Executive Director's Recommendation
Commission Meeting: July 11, 2013

Phase 2 (South Campus), Centrum

Intelligence Community Campus - Bethesda
(MP7257)
4600 Sangamore Road
Bethesda, MD

Final approval of site and building
plans

Figure 11: East-west cross-section of Centrum
(Image date: June 6, 2013)

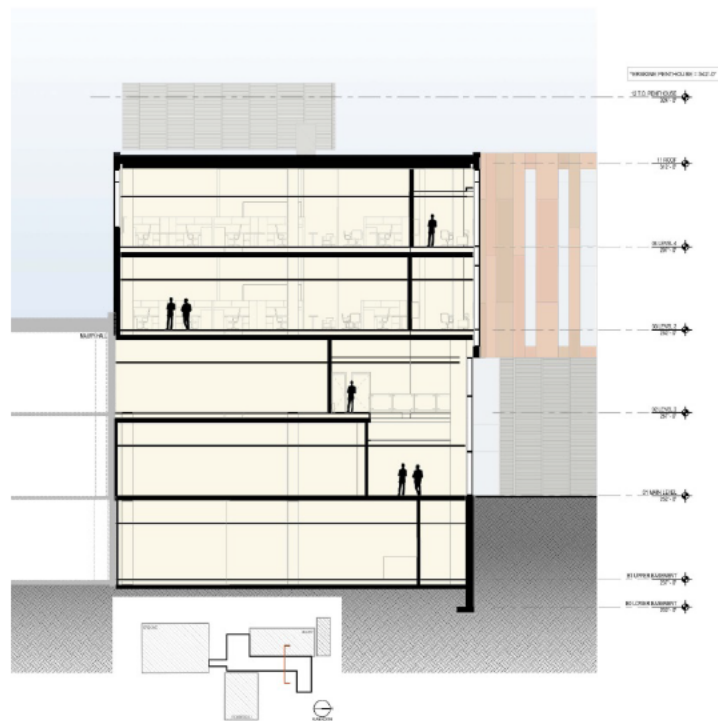
As currently designed, the height of the Centrum measured from grade to the parapet will be 60 feet, and 72 feet to the top of the mechanical penthouse. (Figure 11) This is consistent with the height of Roberdeau Hall and below that of Erskine Hall. In terms of impacts to views, it is helpful to compare the Centrum to Erskine Hall, the tallest building on the site. Following construction, the top of the Centrum penthouse will rest at 324 feet above mean sea level (msl). Meanwhile, the Erskine Hall penthouse has an elevation of 342 feet above msl, 20 feet higher than the Centrum. The end result as it pertains to visual impacts should be that views from the east along Sangamore Road, and from the north and south will not be adversely impacted since the height and massing of the Centrum are consistent with existing buildings. In addition, there will be several instances where views of the Centrum will be blocked by existing buildings or in some cases dominated by Erskine Hall.

Figure 13: Roof plan of Centrum
(Image date: June 6, 2013)

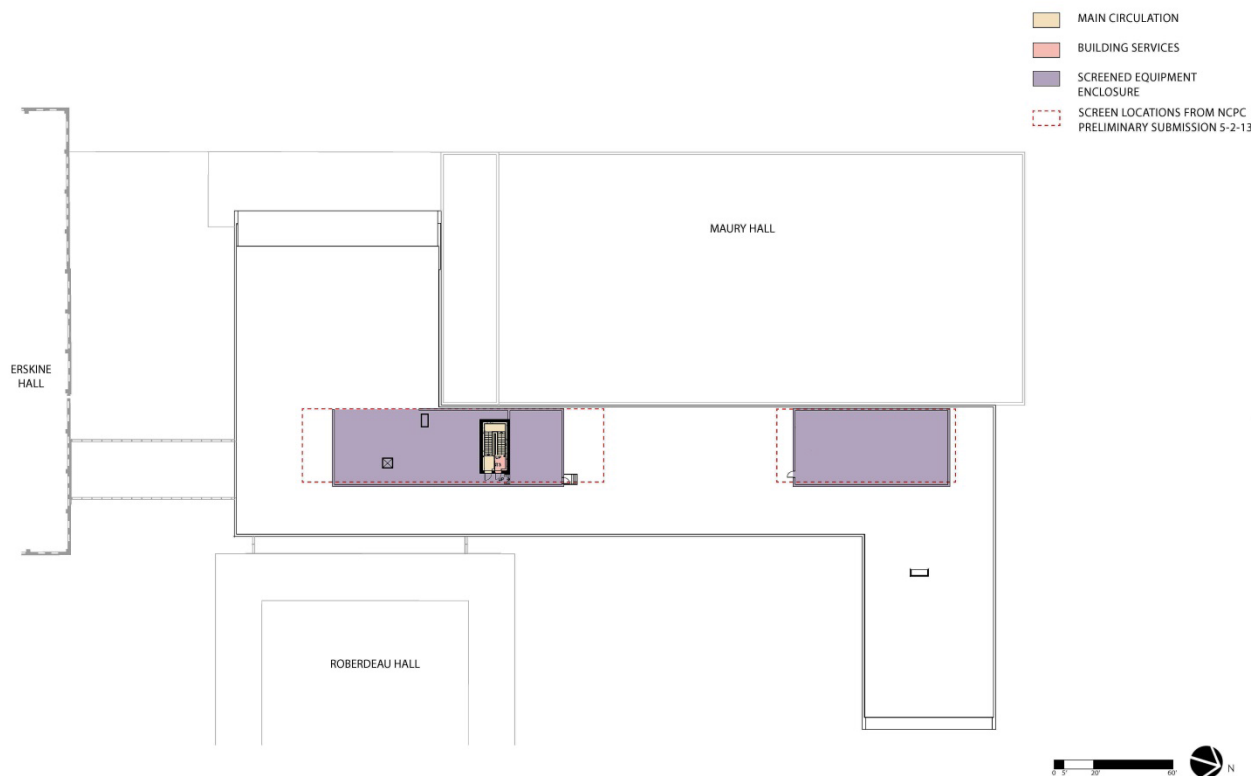
In regards to the mechanical penthouses proposed for the Centrum, within its preliminary review, the Commission requested that the applicant evaluate whether any reductions in the penthouse height and massing can be made, and to evaluate setting back the penthouses from all exterior walls a distance greater than or equal to their height in order to further minimize any potential views of the penthouses from the west, and strengthen the architectural presence of the Centrum when viewed from the east. In response, the applicant was able to eliminate the northeastern-most penthouse, which provided roof access, by replacing it with a roof hatch. In addition, the applicant reduced the footprints of the remaining two penthouses by reducing their north / south lengths. This, in turn, has reduced their respectable distances from both the north and south walls of the Centrum. (Figure 13) However, the applicant notes in their final submission materials that the use of smaller HVAC units was explored but that they found no other equipment that met program requirements at a smaller scale. As such, the proposed height of the penthouse enclosures has remained at 12 feet, as presented in the preliminary review, to minimize the visibility of the HVAC units. (Figure 14)

Figure 15: Location of Centrum's green roof
(Image date: June 6, 2013)

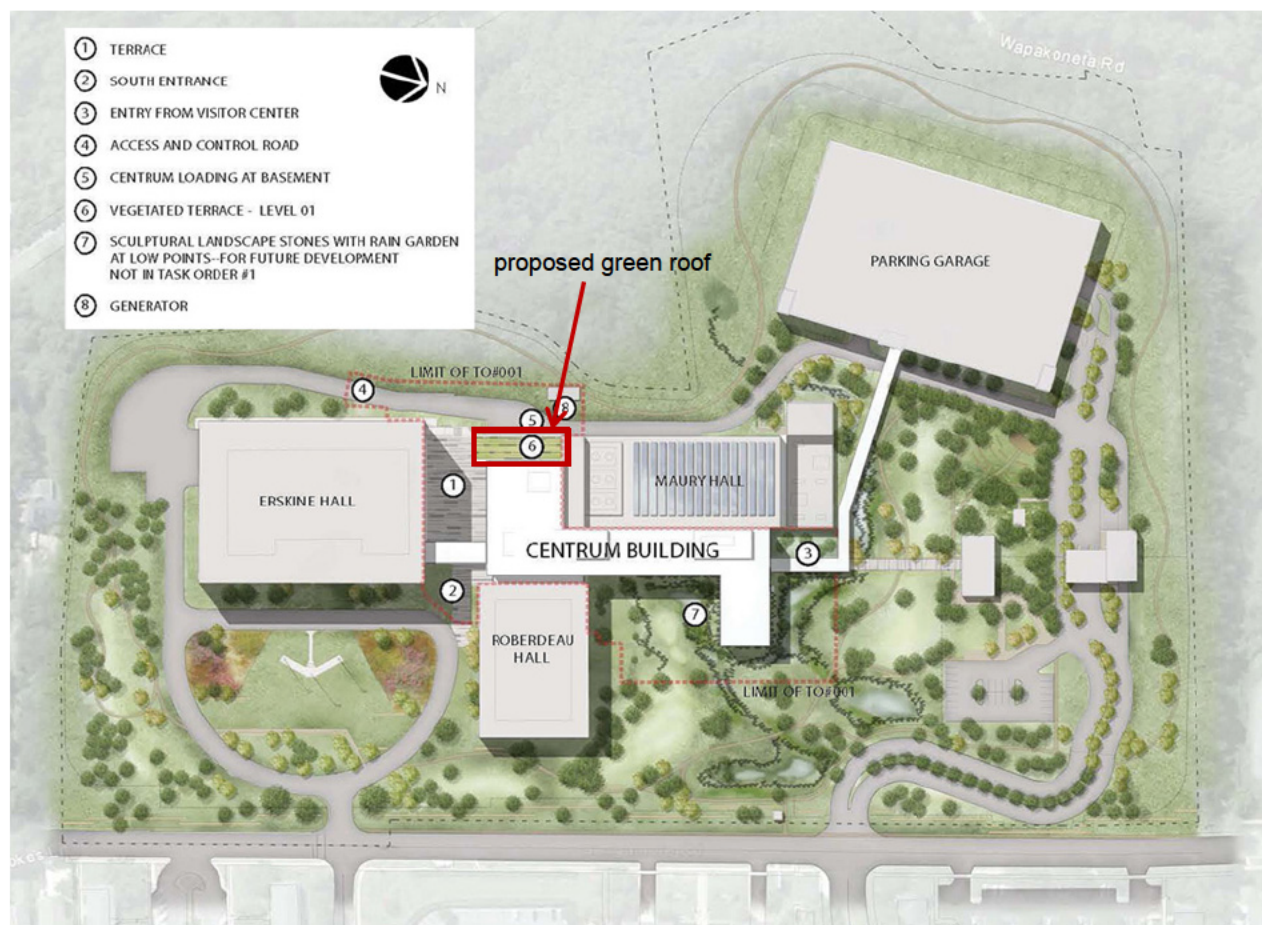
Staff commends the applicant for its use of a green roof over the loading dock, and a cistern to capture and reuse runoff from a portion of the Centrum's roof. Staff supports the use of ESD strategies to manage stormwater to the maximum extent feasible, and notes the added benefits that these strategies have beyond reducing runoff. For example, the benefits to a green roof system are well documented, and include:

The proposed green roof is only located over the loading dock, an area of approximately 3,600 square feet. (Figure 15) This is a relatively small portion of the total Centrum roof area which measures approximately 41,000 square feet. The Commission, at its preliminary review of the project, requested that the applicant consider expanding the area of the proposed green roof and to design the system to the greatest depth possible. In response, the applicant states that an

expanded green roof system would require substantial structural upgrades to the Centrum building and that to design the proposed system to the greatest depth possible would require a vertical expansion of the height of the green roof structure because it would need to occur above the structural roof slab of the floor below. The applicant also notes that from a stormwater perspective, it is more cost effective to treat stormwater at grade level than on occupied structure, but will continue exploring additional stormwater management opportunities that are both
